**Monitoring Report
Year 4
FINAL**

Little Buffalo Creek Stream Mitigation Project

*NCDEQ-DMS Project Number: 94147
Contract Number: 2029
USACE Permit Action ID: 2014-00386
DWR Permit: 14-0129
Cabarrus County*

Subject: DRAFT Monitoring Year 4 report for the
Little Buffalo Creek Stream Mitigation Project
Yadkin River Basin – CU# 03040105– Cabarrus County
DMS Project ID No. 94147
Contract # 002029

**Figure 7a-7d – Random Vegetation Plot Transects
Location Maps**

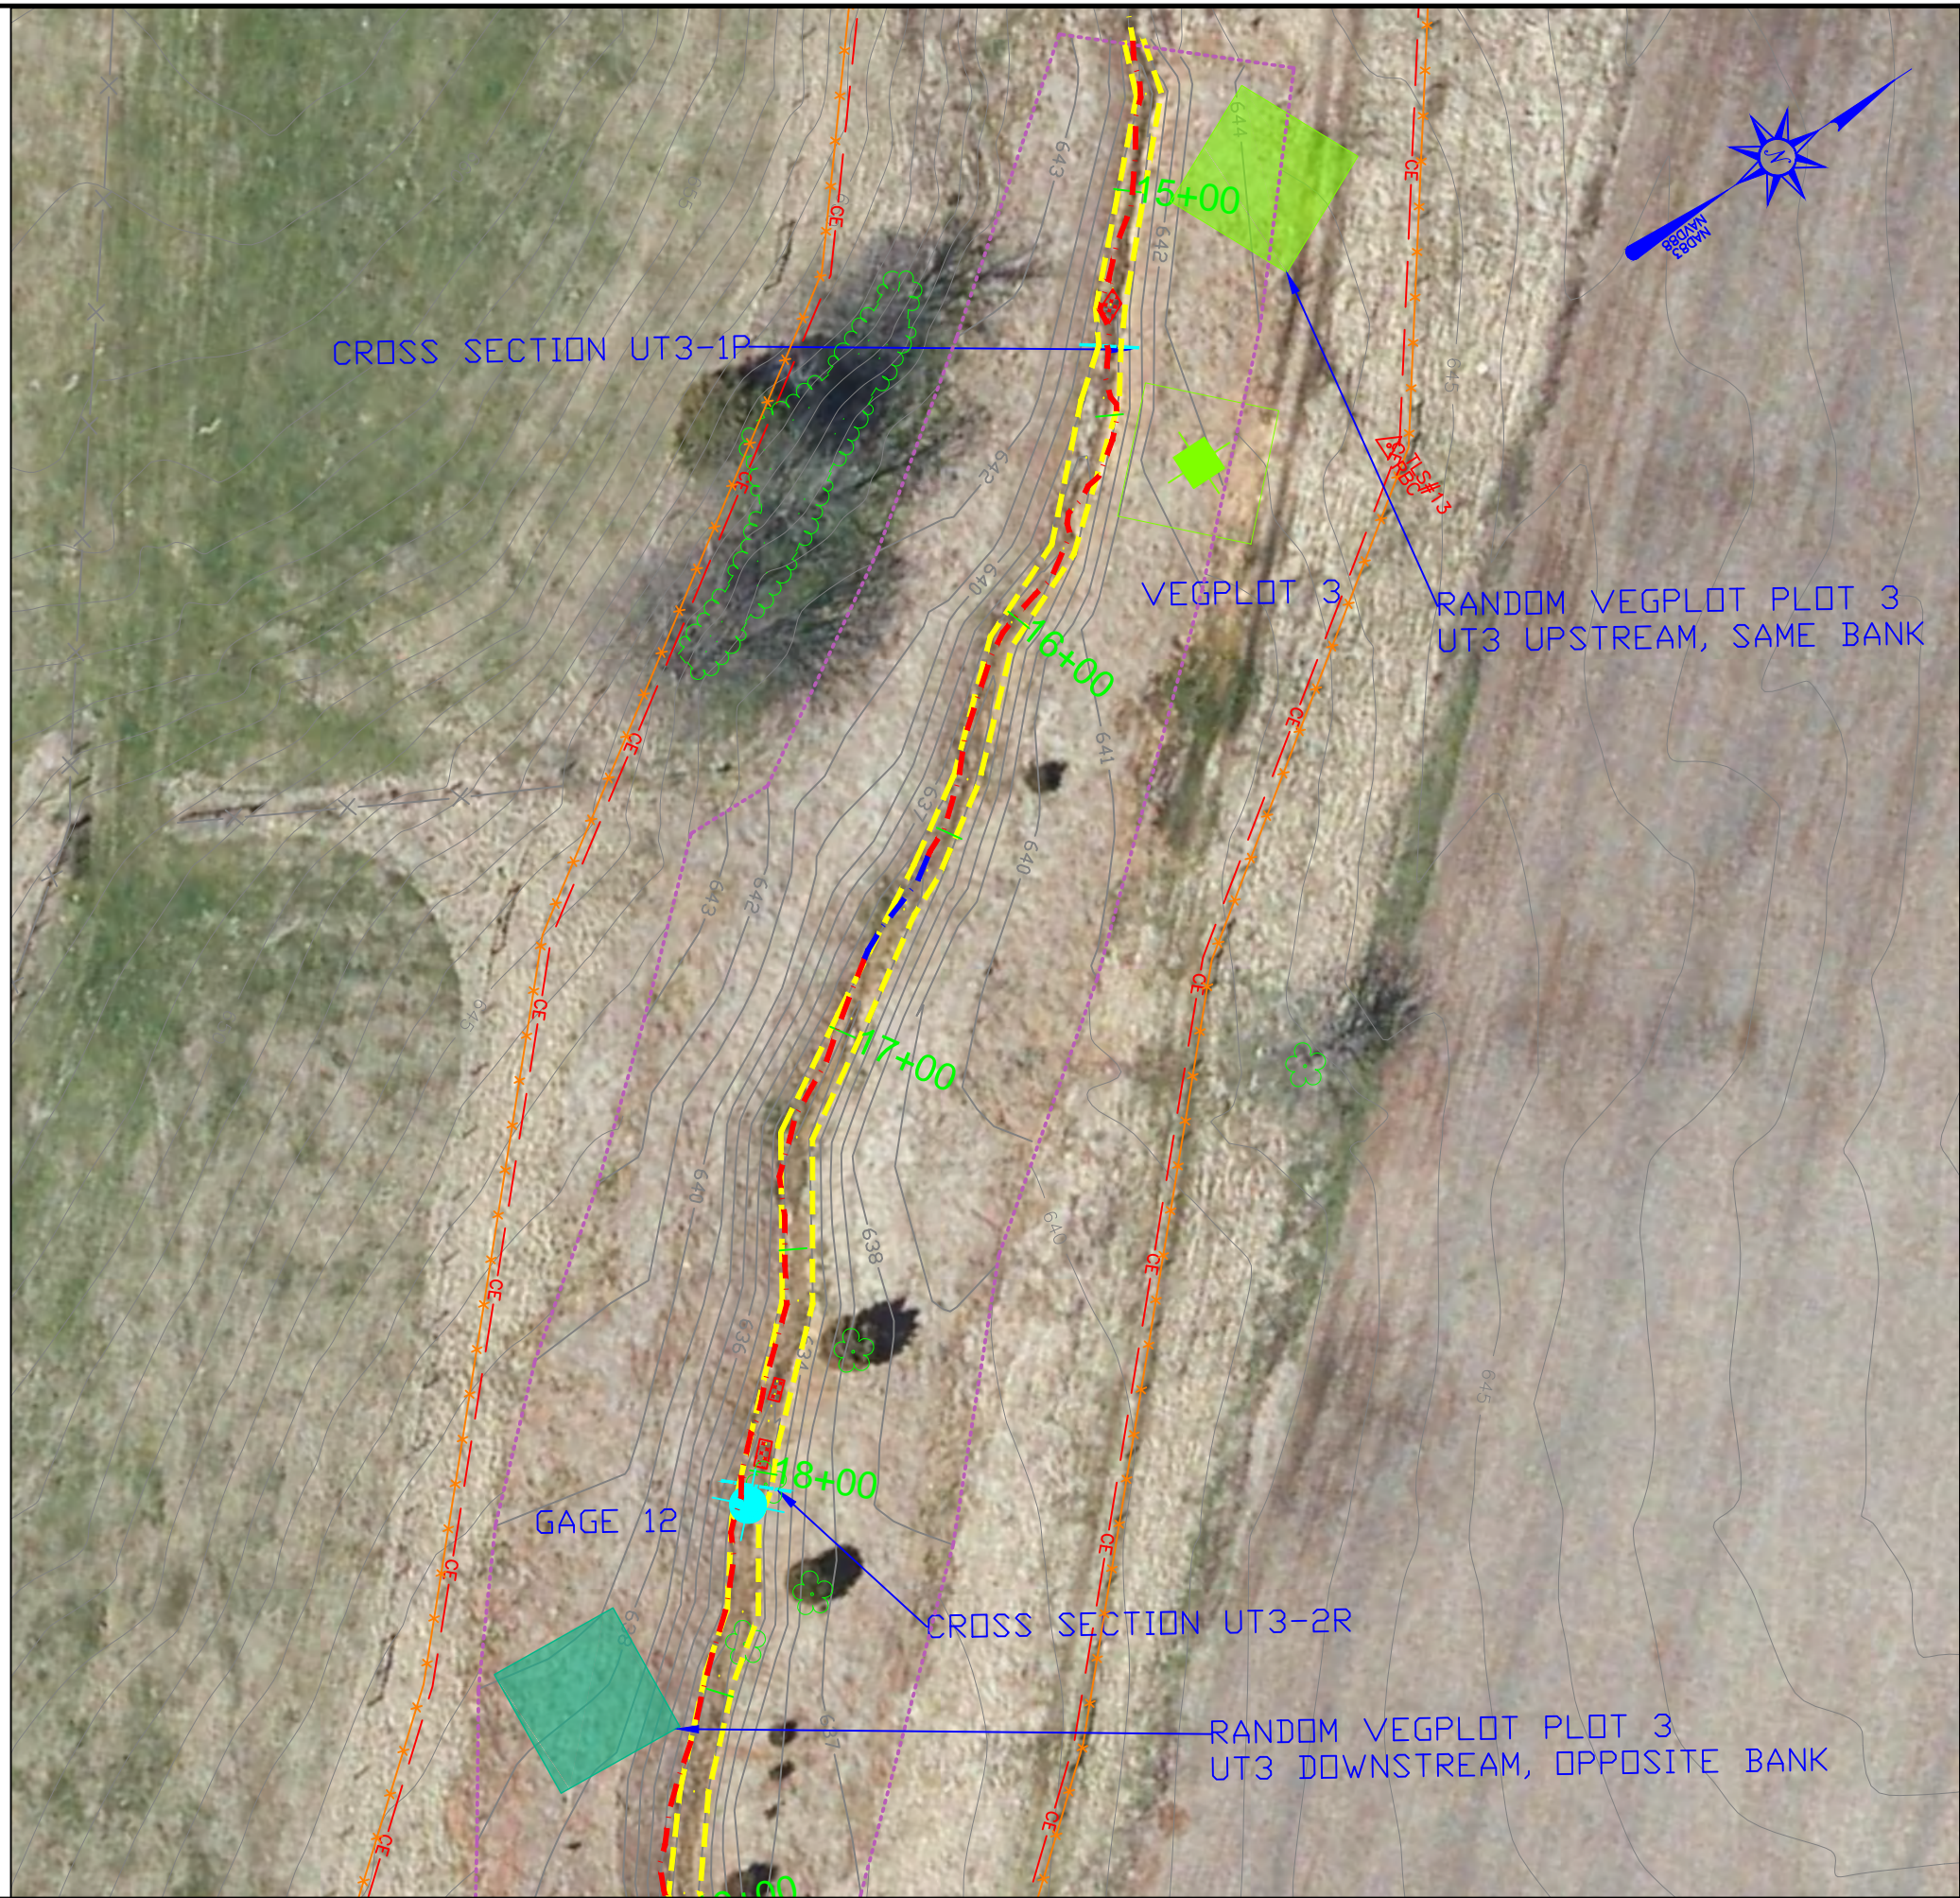
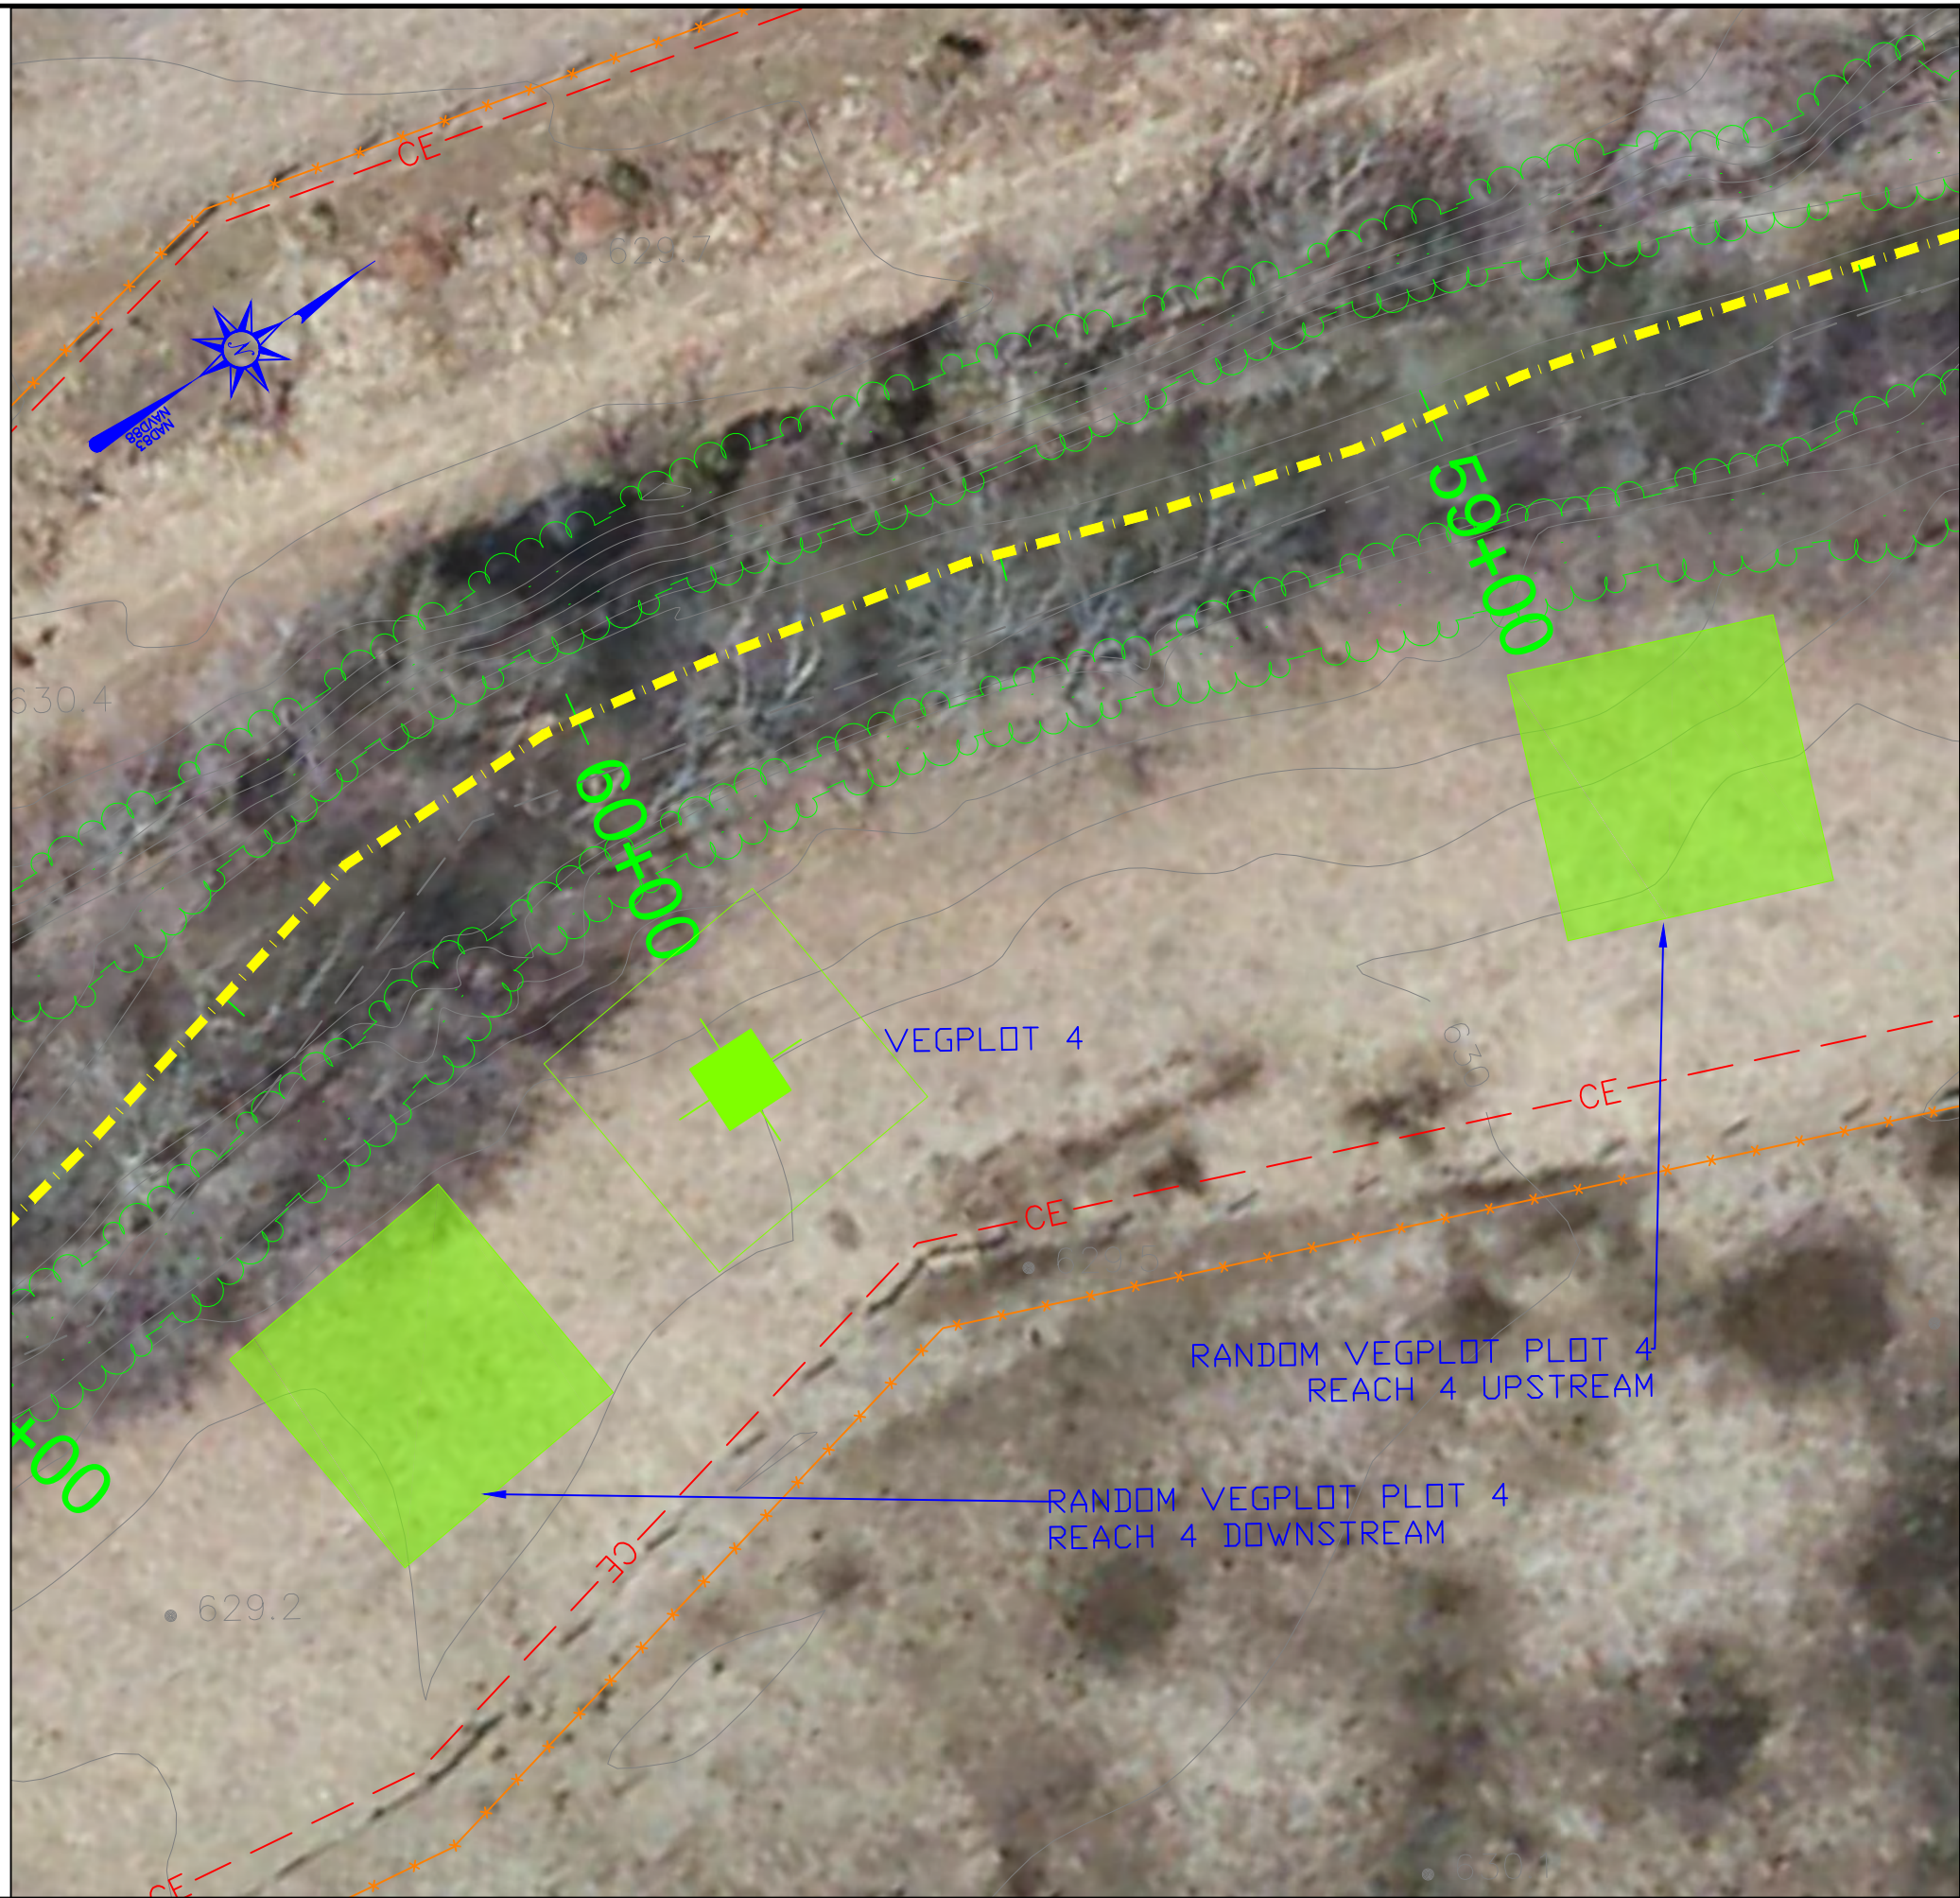
Section 1.5.1.3 – Random Vegetation Plots: The report text indicates that the random vegetation plots are shown in Figure 2. The plots are shown in the CCPV sheets but they do not appear to be in a standalone figure 2. Please update the report text accordingly. DMS recommends including a simple map or set of simple maps showing the random plots to go along with Table 14 in the report appendices.

- **Section 1.5.1.3 – Random Vegetation Plots:** The report text indicates that the random vegetation plots are shown in Figure 2. The plots are shown in the CCPV sheets but they do not appear to be in a standalone figure 2. Please update the report text accordingly. DMS recommends including a simple map or set of simple maps showing the random plots to go along with Table 14 in the report appendices.
 - *Figure 2 is referring to Figure 2a- 2j for the MY4 CCPV. The report text has been updated accordingly to refer to the CCPV. Figure 7a-d has been created and placed with Table 14 to show closer views of each random transect in relation to the vegetation plot.*
